Notice of Intent

Sundry ID: 2757294

Procedure Description: Cross Timbers Energy, LLC requests approval to plug and abandon the MKL #15. Attached is the Proposed Procedure and WBDs.

MKL 15

Proposed SLIMHOLE P&A

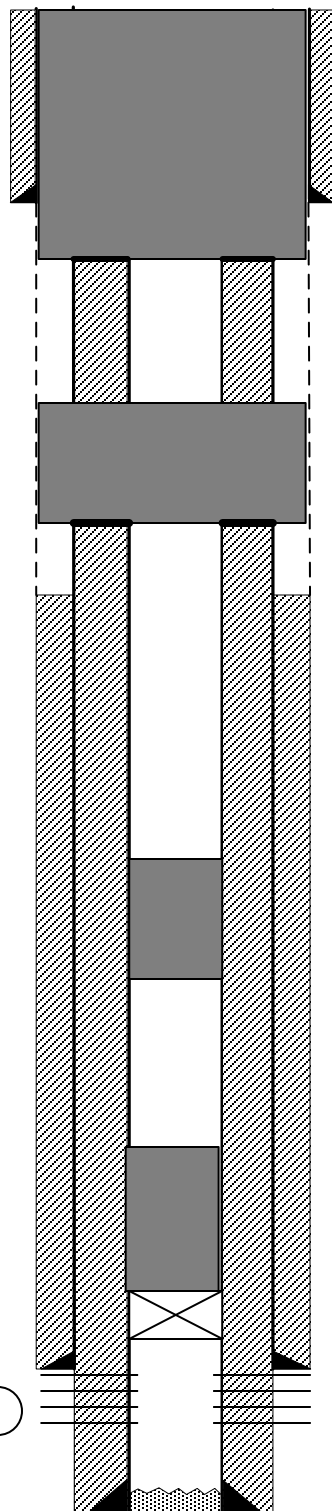
You are also required to place cement excesses per 4.2 and 4.4 of the attached General Requirements.

4.2 All cement plugs placed inside casing shall have sufficient volume to fill a minimum of 100' of the casing, or annular void(s) between casings, plus an excess volume sufficient to provide for 50 linear feet of fill above the plug.

4.4 All cement plugs placed to fill annular void(s) between casing and the formation shall be of sufficient volume to fill a minimum of 100' of the annular space plus 100% excess, calculated using the bit size, or 100' of annular capacity, determined from a caliper log, plus an excess volume sufficient to provide for 50 linear feet of fill above the plug.
